Medical Device Application

Application ID: 030422-WEBE-5LU7L3

Sponsor's own reference: 8637 SynchroMed II Programmable Pumps

Submission ID	DA-2023-08940-1
Application ID	DV-2023-DA-32797-1
TRIM Reference	E23-355088
Sponsor Name	Medtronic Australasia Pty Ltd
Manufacturer Name:	MEDTRONIC INC
UPI/Sponsor's reference	Synchromed III 8667
Classification	III
GMDN Term & Code	Intrathecal implantable infusion pump, programmable [46024]

[D23-4078334](#): PIC label

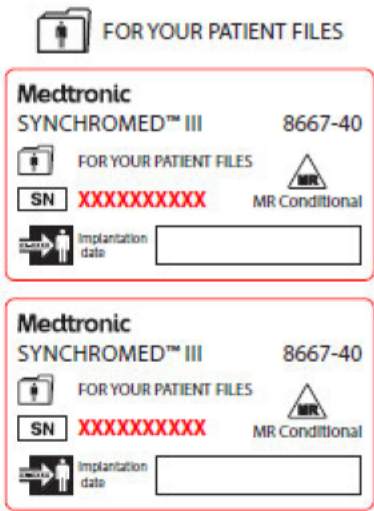
Does the Patient Implant Card comply with EP 13A.2?	YES
---	-----

Device label - Version and build number of the software.

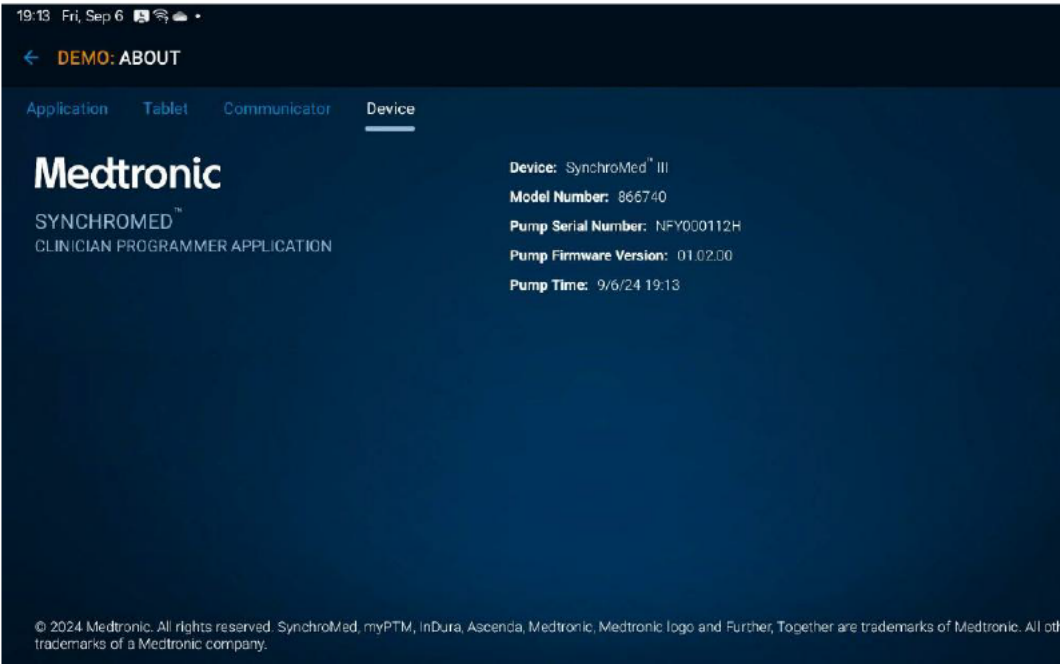
EP 13 B Item	Compliant?
1. For a medical device that is software, or that incorporates software, the current version number and current build number of the software must be accessible by, and identifiable to, users of the device.	YES
2. The current version number and current build number of the software: (a) must be in English; and (b) may also be in any other language	YES

The version and build information for the Synchromed III device is located under the "About" tab in the 810 Clinical Programmer Application software (supplied separately under ARTG 308884).

The version number shown against the "Pump Firmware Version", and the build number are the least significant digits after the Version. Refer to **Attachment 3.01 About Screen (Snapshot)**
